Accessibility Survey

City of Downey Dalewood Avenue - Brookpark Road to Cul-De-Sac

Date of Inspection
6/17/2017

Disability Access Consultants

Tree North of Cul-De-Sac @ 33.946753207793, -118.099804669619

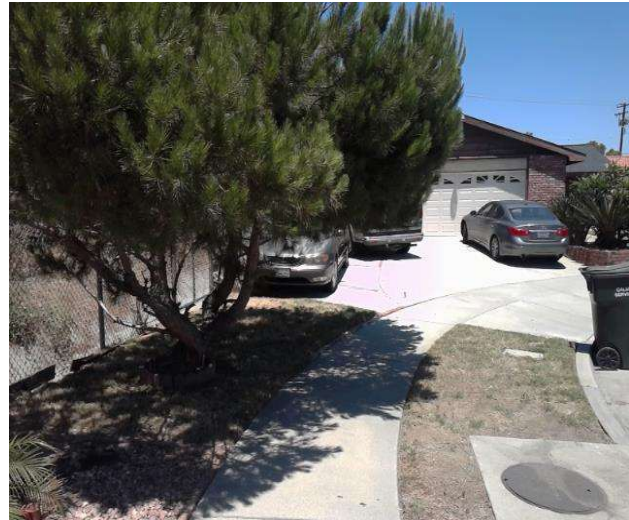
Overhead obstruction height is not compliant.

On-Site Finding 60.00 inches

Provide a compliant vertical clearance height.

Recommendation At least 80.00 inches

Change in Level North of Pico Vista Road @ 33.948762399685, -118.097894936800

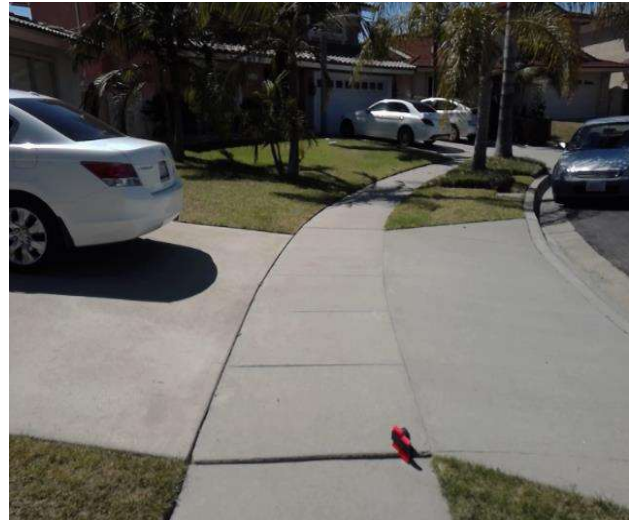
There is a change in elevation greater than recommended value.

On-Site Finding 0.75 inches

Ensure that the change in elevation is within the recommended value.

Recommendation Up to 0.25 inches

Change In Level South of End @ 33.933330678413, -118.096549808979

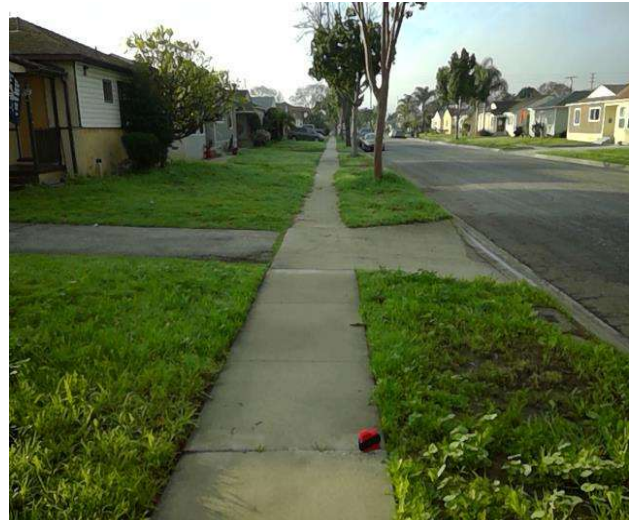
There is a change in elevation greater than recommended value.

On-Site Finding 0.87 inches

Ensure that the change in elevation is within the recommended value.

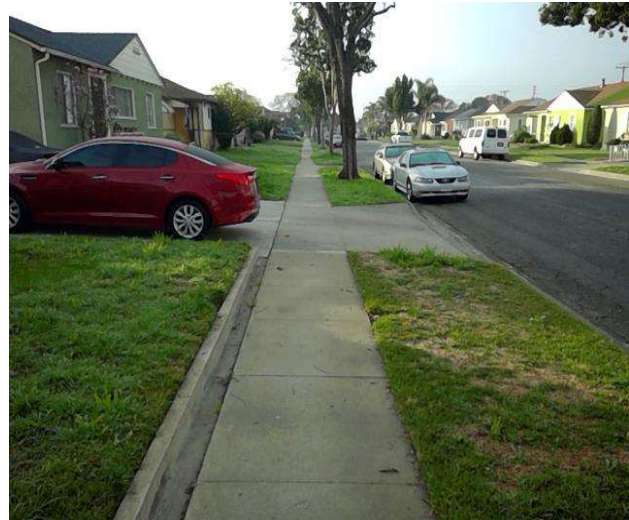
Sidewalk cross slope is not compliant.

On-Site Finding 2.80 percent for 90.00 feet

Repave the sidewalk surface with the recommended cross slope.
